**RABEAA POINT OF ENTRY
SCREENING FACILITY
RABEAA, IRAQ**

**SIGIR PA-09-173
JANUARY 11, 2010**

Rabeaa Point of Entry Screening Facility

Summary of Report: PA-09-173

Site Photo 5. Electrical conduit embedded in interior wall

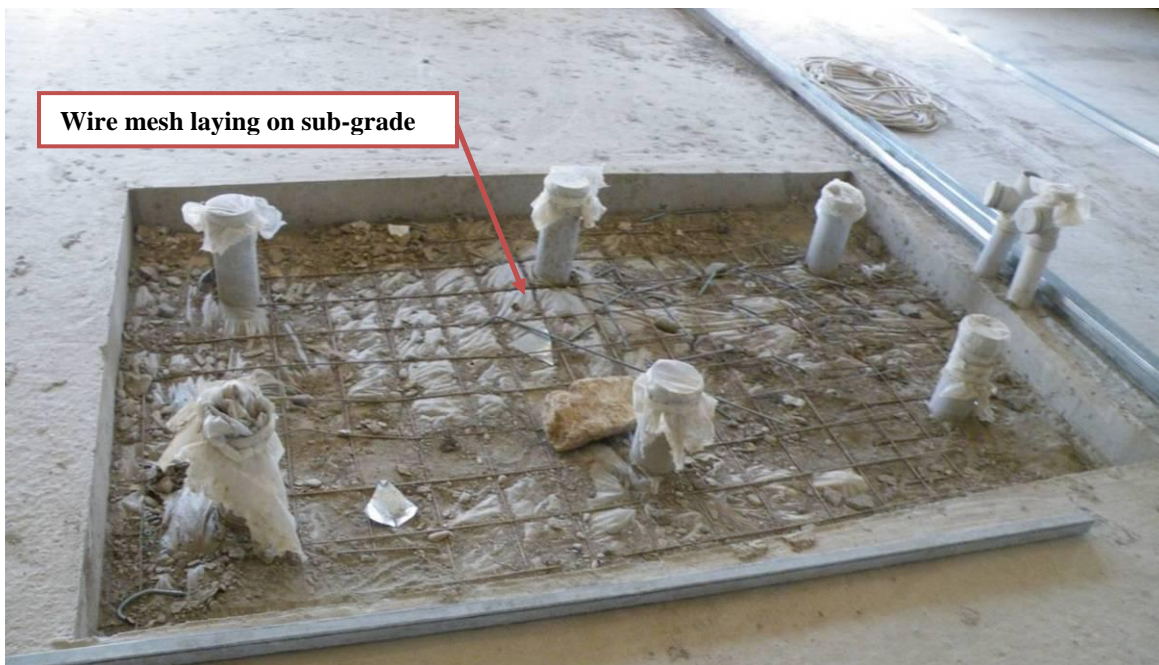
The conduit for future electrical wiring was embedded in the interior masonry walls (Site Photo 5). The SOW, Section 26.2.1 required that all building electrical lines were to be "surface mounted in conduit vice embedded." In addition, the conduit used did not match the COR approved product submittal.

Figure 5. Sidewalk detail per the 100% design drawings (Courtesy of USACE)

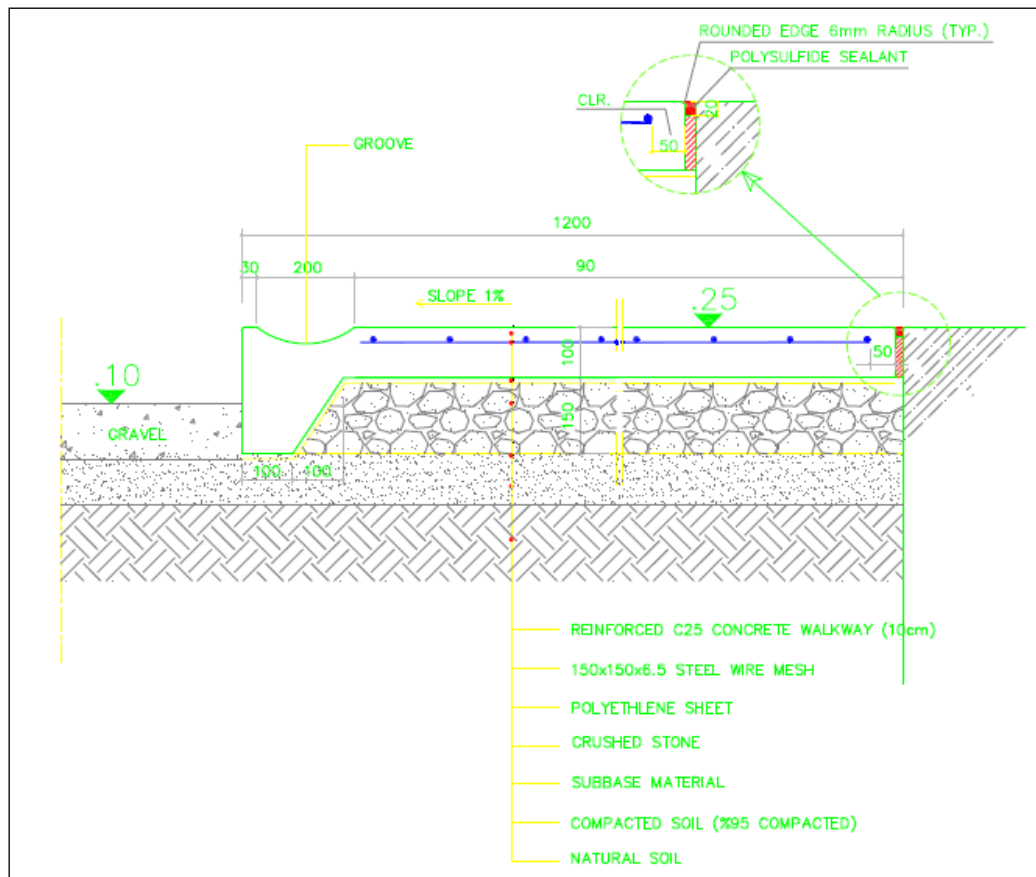
At the time of the site assessment, the exterior sidewalk was partially constructed; the construction was determined to be lacking an isolation joint next to the building, control joints, and a 200mm groove (Site Photo 9). Both the isolation joint and the groove were included in the 100% drawings submitted for approval (Figure 5). The control joints (contraction joints) were required every 1.2 meters (m) per a special note on the plans.

Figure 6. 100% Water pump room floor plan drawing (Courtesy of USACE)

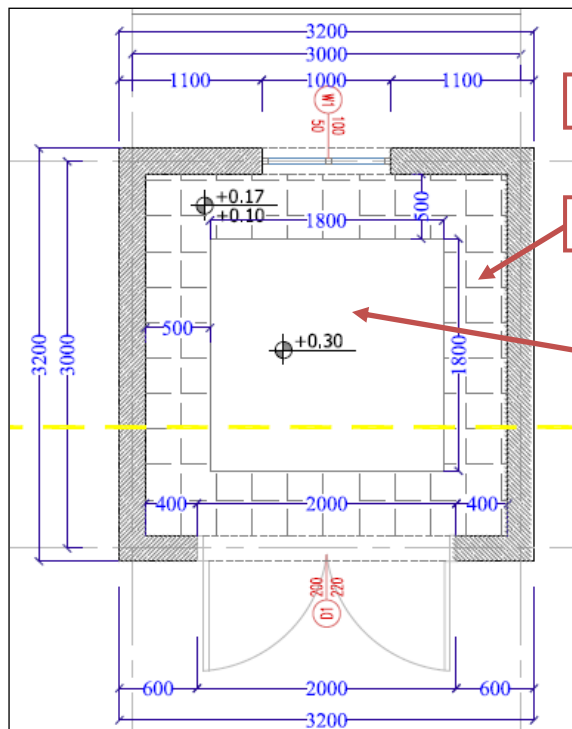
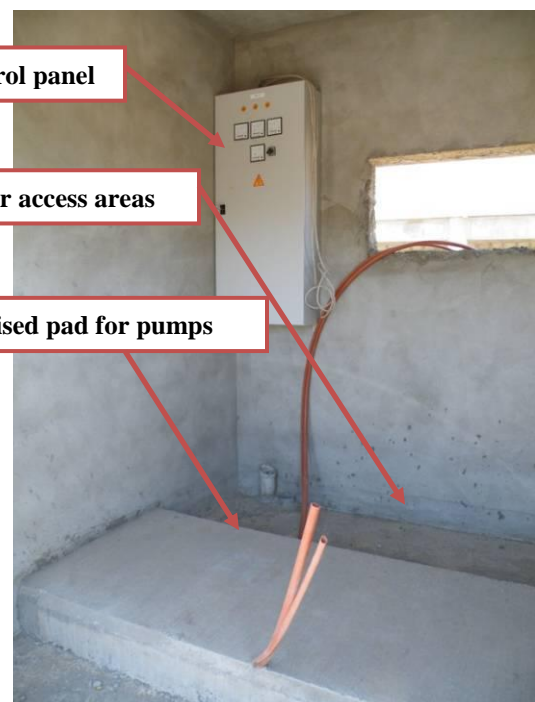
Although the construction of the water pump house was partially completed, SIGIR noted that the construction of the raised concrete pump pad was not constructed in accordance with the drawings (Figure 6 and Site Photo 10). Specifically, the raised floor as submitted on the plans was a 1.8m square raised concrete pad. The actual construction of the raised concrete pad was not configured in a square and did not allow for access against one exterior wall. Once the booster pumps are placed on the concrete pad, the access to the electrical control panel could be impeded. The original design allowed for unimpeded access all around the raised pump pad.
